Administrative Order NSL – 8888

Cimarex Energy Co. [OGRID 215099]
Southern Hills 32 29 Federal Com Well No. 4H
API No. 30-015-49516

RE: Application of Cimarex Energy Co. for administrative approval of unorthodox well location for its Southern Hills 32-29 Federal Com 4H well located in a horizontal spacing unit comprised of the W/2 of Sections 32 and 29, Township 25 South, Range 27 East, Eddy County, New Mexico.

C-102 Submit Electronically Via OCD Permitting	State of New Mexico Energy, Minerals & Natural Resources Department OIL CONSERVATION DIVISION	Revised July 9, 2024
		Submittal Type: <input type="checkbox"/> Initial Submittal <input type="checkbox"/> Amended Report <input type="checkbox"/> As Drilled

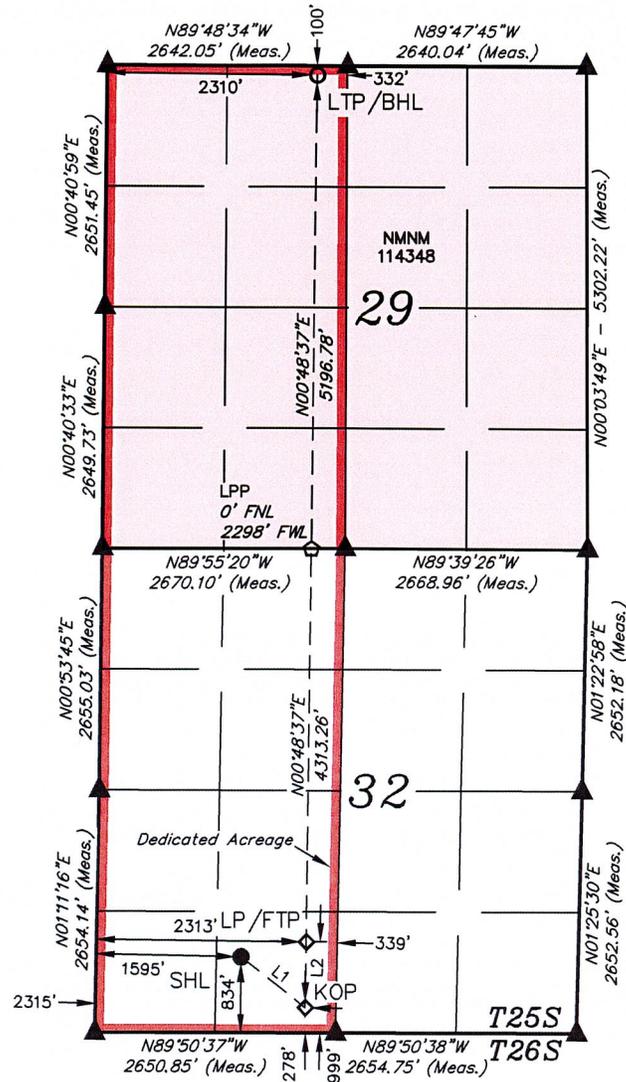
ONE – Is the Section 32 composed of Lots? The 339 ft + 2313 ft = 2652 ft. Larger than the standard 2640 ft for a standard QTR – QTR unit.

TWO – If the 2313 ft is correct, then that would make the FTP encroaching towards the eastern boundary as the set backs would be in 327 ft, less than 330 ft. Did Cimarex provide notice towards the eastern boundary?

THREE – the “Offset Ownership – Notice Table”, indicates that it provided notice to “Section 20”, is that correct? Why? The LTP is located 330 ft from the boundary, an orthodox distance.

standard 2640 ft for a standard QTR – QTR unit. Section 32 is not comprised of lots but it is wider than 2640'. The map below, from BLM's website, shows the W/2 is 40.20 chains, which means it is approximately 2653.2 feet on the section line.

Because the W/2 is wider than 2640', I think that answers this question because the completed lateral at the FTP would still be more than 330 ft. $2652 - 2313 = 339'$ So, no notice would be needed towards the eastern boundary because the location is standard.

THREE – the “Offset Ownership – Notice Table”, indicates that it provided notice to “Section 20”, is that correct? Why? The LTP is located 330 ft from the boundary, an orthodox distance. I included the wrong C-102. The correct C-102 has the LTP at 100'. I will provide the correct C-102 with the revised packet I submit today.

Southern Hills 32-29 Fed Com Area

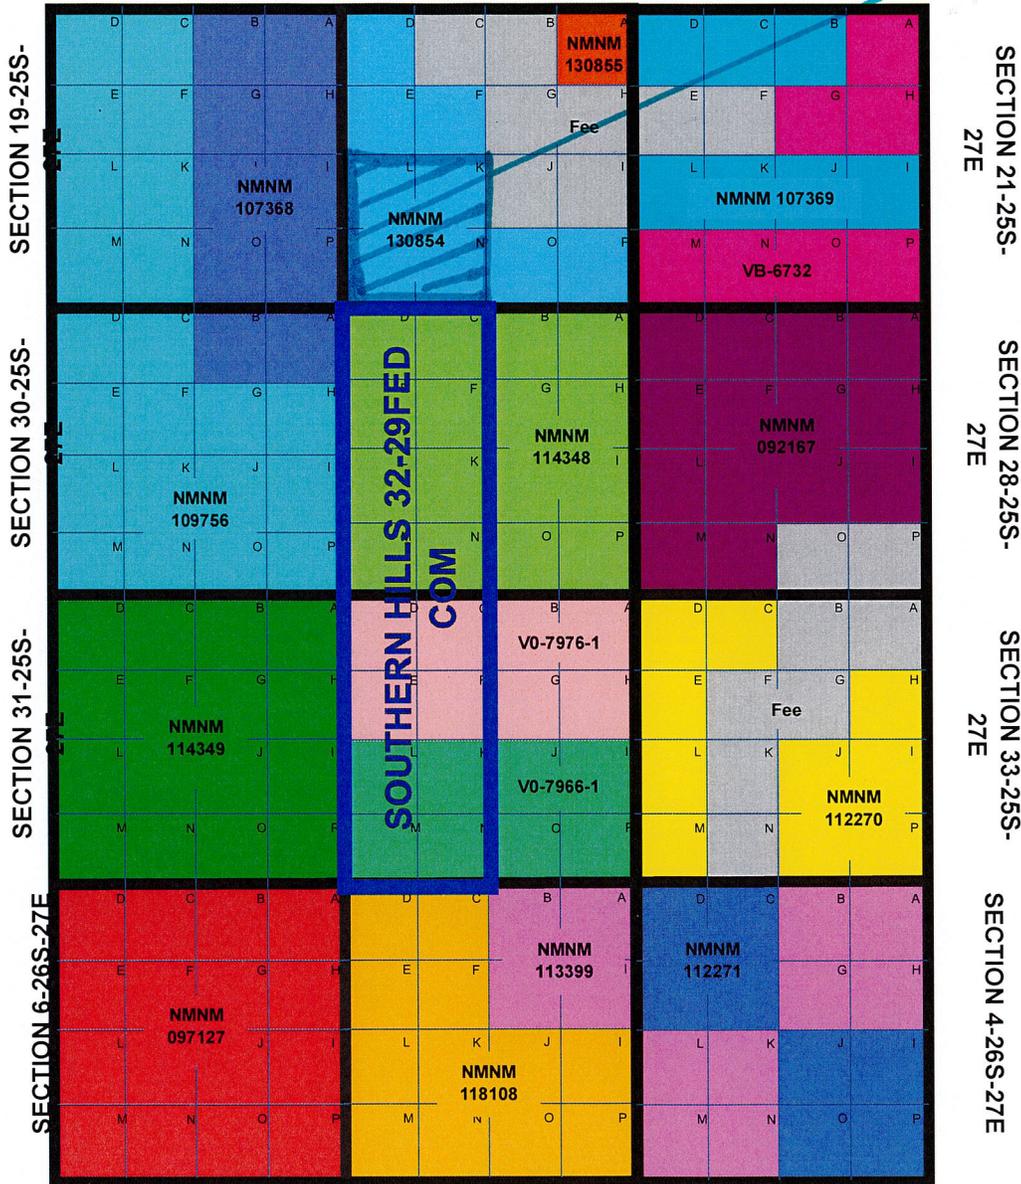
4. On your Affected Notice Map (Exhibit C) within your application, please indicate/highlight the area on the map the affected parties were noticed.

- Administrative Checklist: No change
- Cover Letter: New—this is the letter that I explained was left out accidentally from our filing. As you will see on the cover letter, the spacing unit is 640-acres; it is the W/2 of Sections 32 and 29, Township 25 South, Range 27 East, Eddy County, NM; and the last take point will be closer than 330' from the outer boundary of the spacing unit and will encroach upon the SW/4 of Section 20.
- Exhibit A: C-102: Updated with the correct C-102 with the non-standard last take point of 100' feet from the north line of Section 29.
- Exhibit B: Reservoir Engineer Letter: No change
- Exhibit C: Affected Notice Map: I indicated by cross hatching the offset tract and also drew an arrow to a text box describing offsetting tract
- Exhibit D: Notice information: No change.

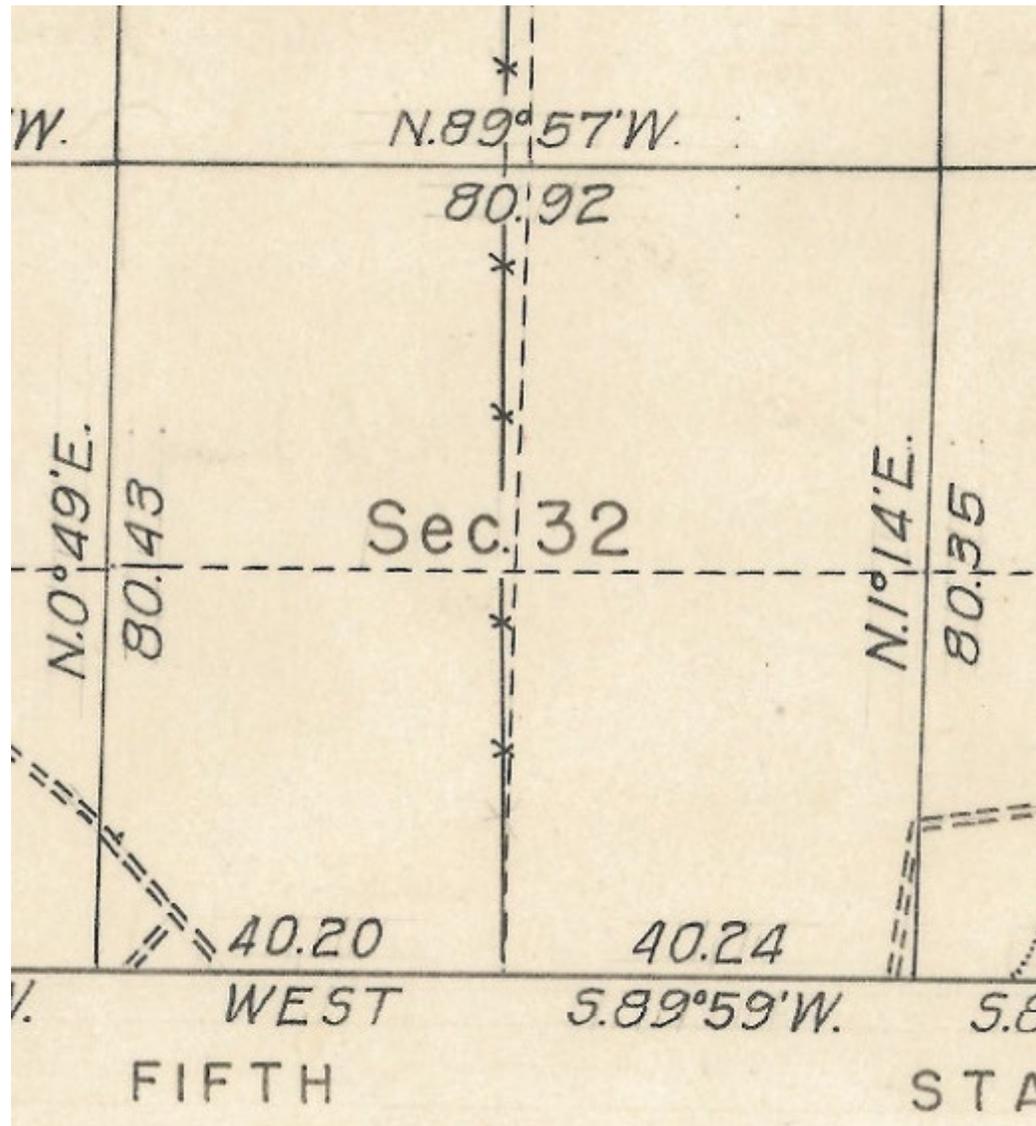
ONE – Is the Section 32 composed of Lots? The 339 ft + 2313 ft = 2652 ft. Larger than the
